VERMONT
STATE HIGHWAY DEPARTMENT
TOWN OF HARTFORD

ROUTES US4 & US5
OVER WHITE RIVER

PLAN & ELEVATION

SHEET 1A

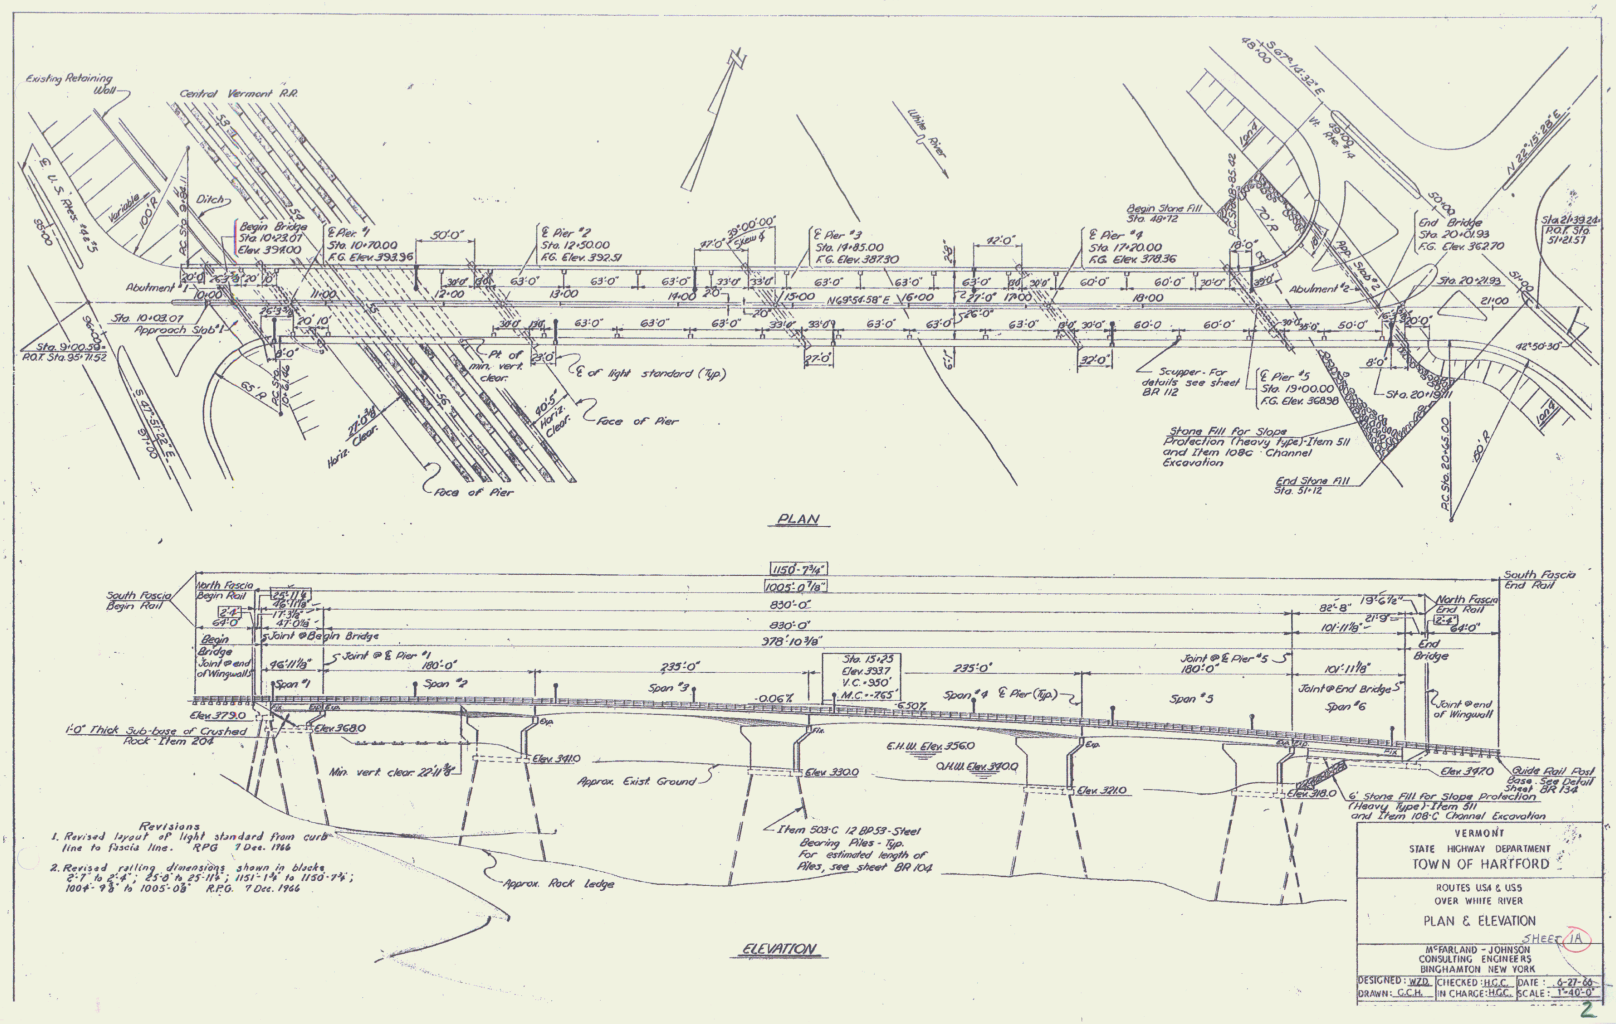
1. Revised layout of light standard from curb line to fascia line. RPG 7 Dec. 1966
2. Revised rolling dimensions shown in blocks 2'-7" to 2'-4"; 25'-0" to 25'-11 7/8"; 1151'-1 7/8" to 1150'-7 3/4"; 1004'-9 7/8" to 1005'-0 7/8" R.P.G. 7 Dec. 1966
